Response Under 37 C.F.R. §1.111  
Serial No.: 10/820,438  
Response dated: March 10, 2006  
In reply to the Office action mailed: November 10, 2005

### ***Amendments to the Drawings***

### **Remarks**

FIG. 2

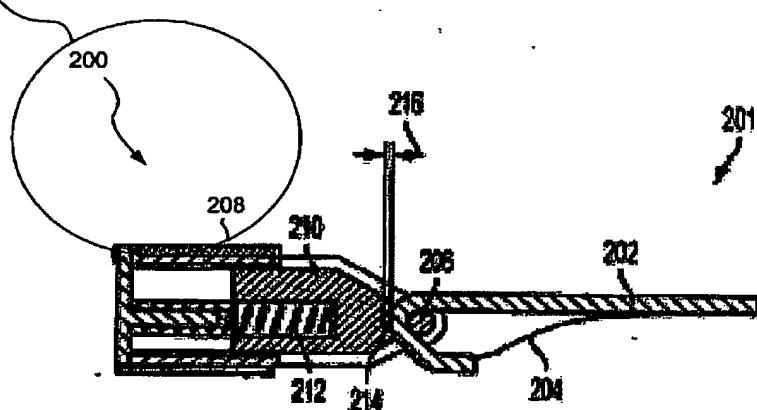
FIG. 2 has been amended to add the reference numerals 200 and 208.

FIGS 2, 4, and 10 were objected to for not including reference signs mentioned in the specification. These figures have been amended to add the missing reference numerals, or where appropriate to replace an incorrect reference numeral with the proper reference numeral. The amendments are called out in the Annotated Sheets and reflected in the Replacement Sheets, appended hereto. No new matter is believed added by these amendments.

Reference  
Numerals -200--  
and -208-- added

**FIG. 4**

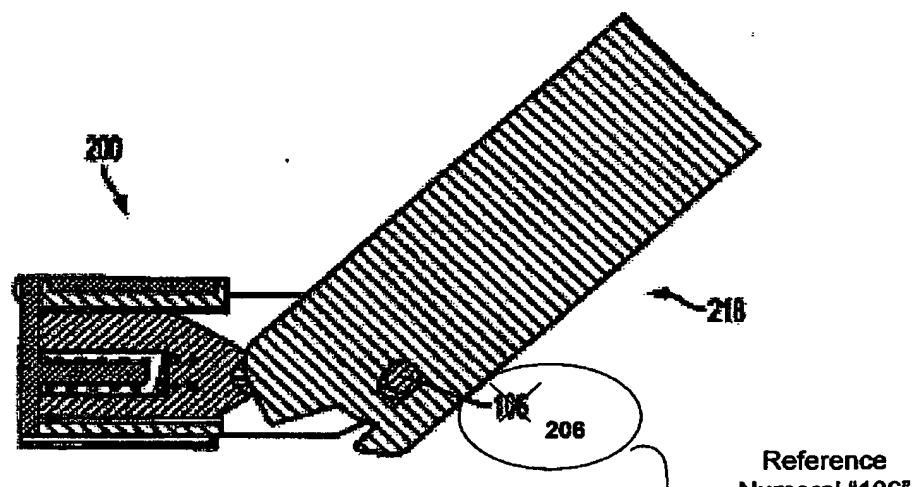
FIG. 4 has been amended to replace the reference numeral "106" with --206--.

FIG. 10

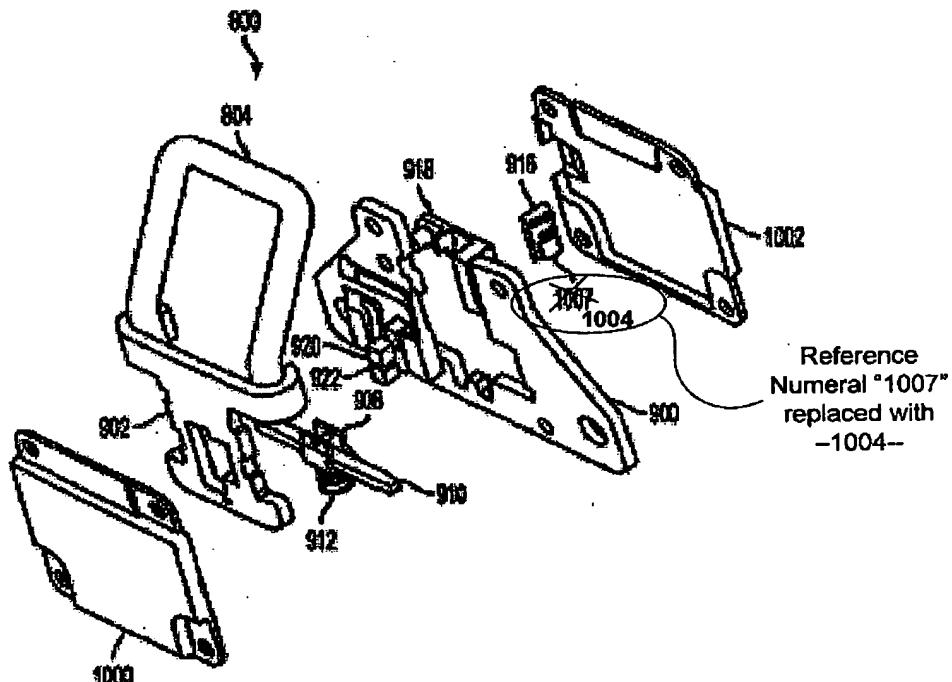
FIG. 10 has been amended to replace the reference numeral "1007" with --1004--.

FIG. 19

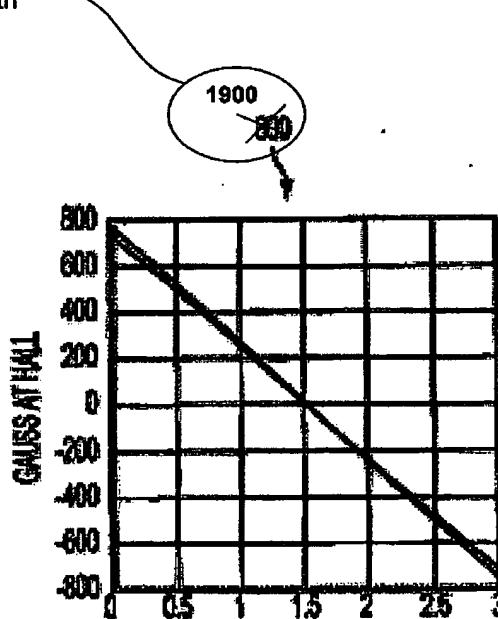
FIG. 19 has been amended to replace the reference numeral "800" with --1900--.

FIG. 19 has been amended herein to replace the reference numeral "800" with the reference numeral "1900". The specification has been amended at paragraph [0057] to read consistently. No new matter is believed added.

Reference  
Numeral "800"  
Replaced with  
-1900-
